World Forum for Harmonization of Vehicle Regulations**Working Party on Passive Safety****Fifty-seventh session**

Item 3(a) of the provisional agenda

**Global technical regulation No.9 (Pedestrian safety) – Proposal for
Phase 2 of the global technical regulation****Proposal for amendments to global technical regulation No. 9
(Pedestrian safety)****Submitted by the expert from the European Commission as Chair of
the Task Force on Bumper Test Area within the Informal Working
Group on global technical regulation No. 9, Phase 2***

"Figure 5A

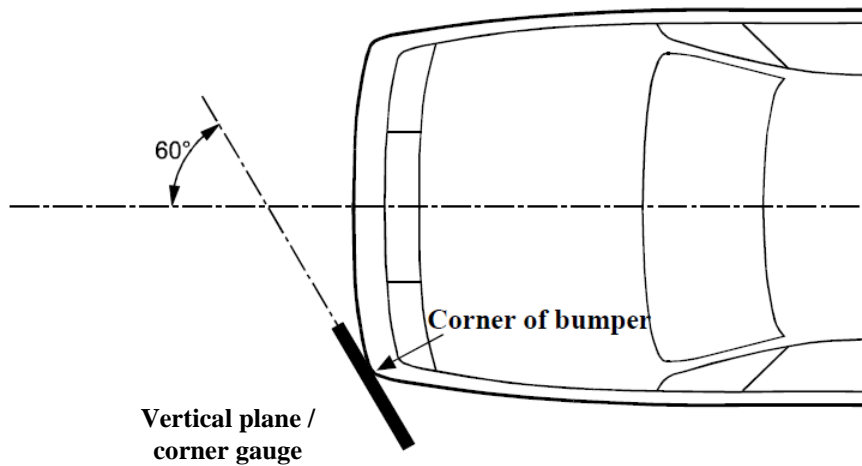
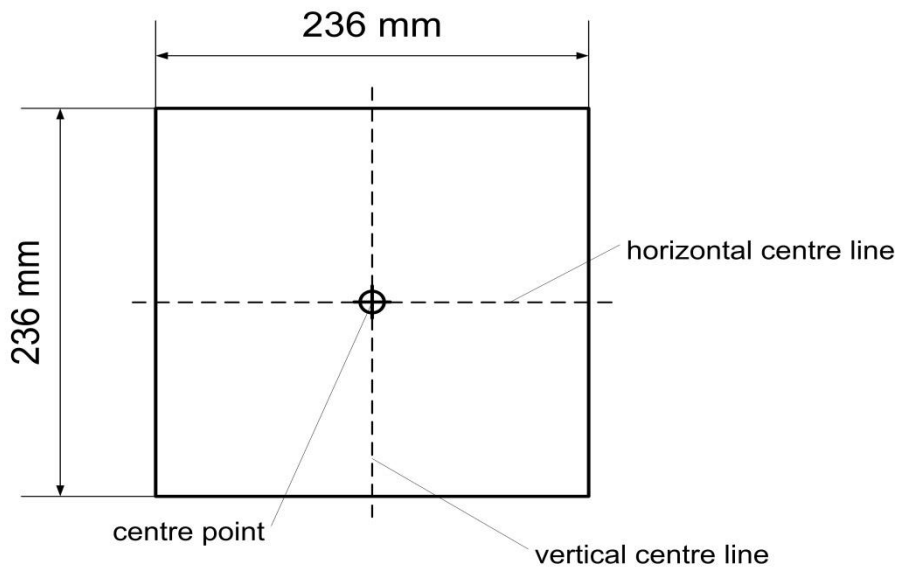
Figure 5, amend to read:

Corner of bumper example (see paragraph 3.14., note that the corner gauge is to be moved in vertical and horizontal directions to enable contact with the outer contour/ front fascia of the vehicle)

"3.14. "Corner of bumper" means the transversal position of the vehicle's point of contact with a vertical plane which makes an angle of 60° with the vertical longitudinal plane of the vehicle and is tangential to the outer surface of the bumper (see Figure 5).corner gauge as defined in Figure 5B.

For determination of the corner of bumper, the front surface of the corner gauge is moved parallel to a vertical plane with an angle of 60° to the vertical longitudinal centre plane of the vehicle (see Figures 5A and 5C) at any height of the centre point of the corner gauge between:

For determination of the corner of bumper, the gauge is moved to contact the outer contour/front fascia of the vehicle touching at the vertical centre line of the gauge. The horizontal centre line of the gauge is kept parallel to the ground plane.

The corners of bumper on both sides are subsequently defined as the outermost points of contact of the gauge with the outer contour/front fascia of the vehicle as determined in accordance with this procedure. Any points of contact on the top and the bottom edges of the gauge are not taken into account. The rear and side view mirrors and the tyres shall not be considered."
